PLANNING AND DEVELOPMENT SERVICES STAFF REPORT

For Planning Commission Meeting of June 16, 2009

**SUBJECT: Near North PUD Zoning District and PUD Site Plan
(626-724 North Main Street) File No. SP08-023**

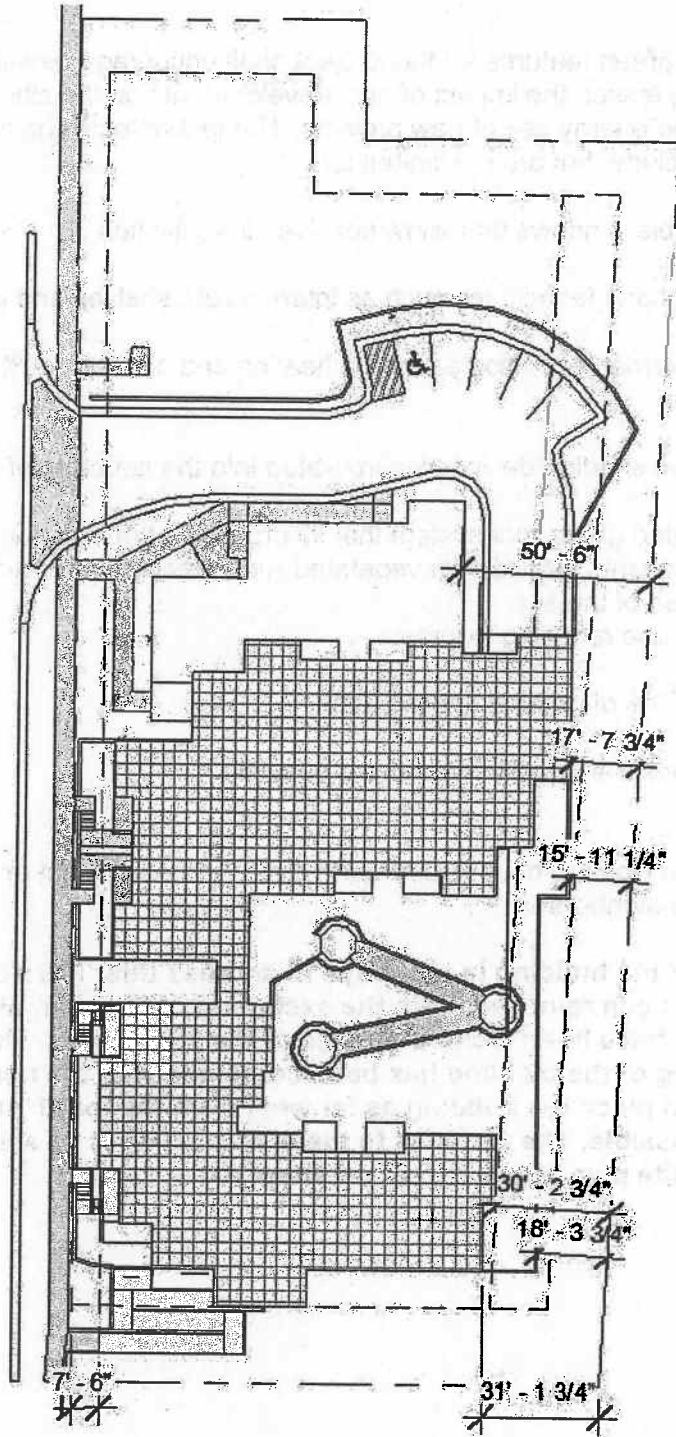
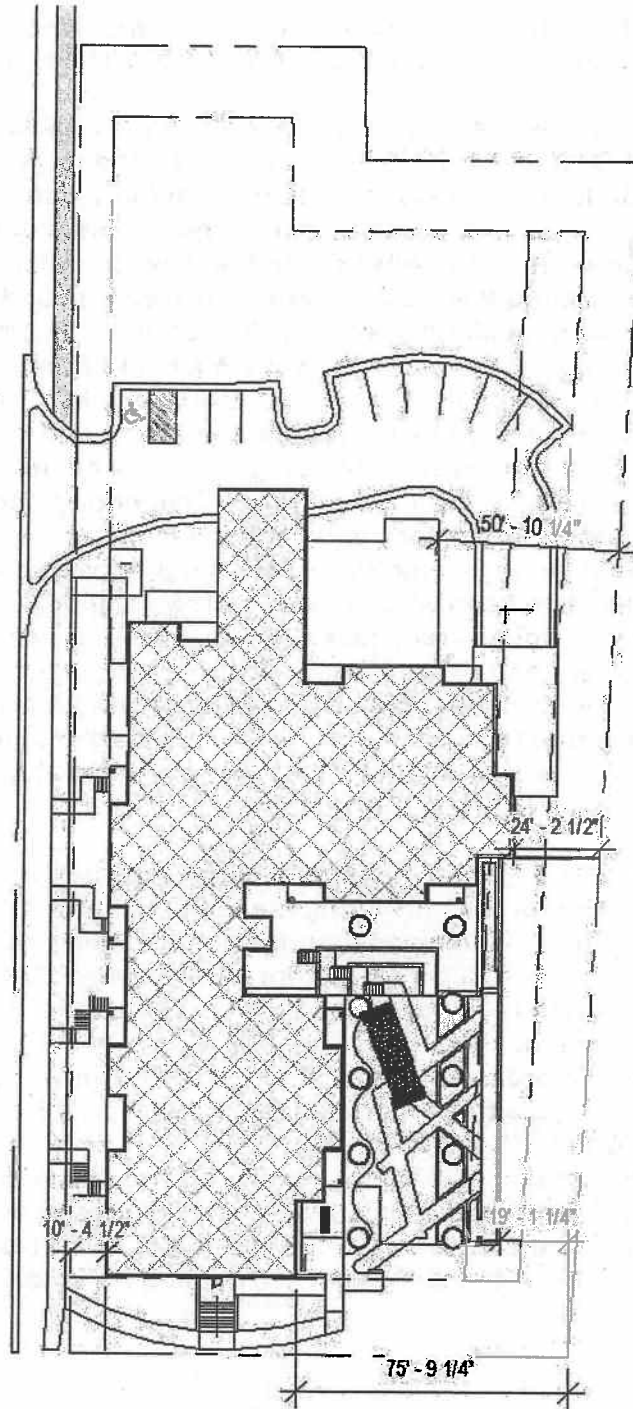
- i. Operable windows that allow passive air ventilation.
 - ii. Day lighting techniques such as internal light shelves and large windows.
 - iii. Geothermal technologies for the heating and cooling 100% of the building.
 - iv. Passive shading devices incorporated into the structure of the building.
 - v. A planted green roof system that incorporates the necessary detention for storm events, providing a vegetated roof surface that covers over 50% of the area of the site.
 - vi. Water use reducing fixtures
 - vii. Over 70% of parking underground.
 - viii. Pervious Parking Surface where possible.
5. Rear setbacks are too close to houses on Fourth Ave. Address height and privacy impacts on adjacent neighbors.

We have revised the building in two ways to address this. The North East corner has been removed. With the exception of the stair, all residential units have been located outside of the 30' setback. The entire south wing of the building has been combined with the north-south corridor to place the building as far west from the fourth street neighbors as possible. The distance to the property line is as shown within the new site plan submittal set on sheet A-1.

Before

After
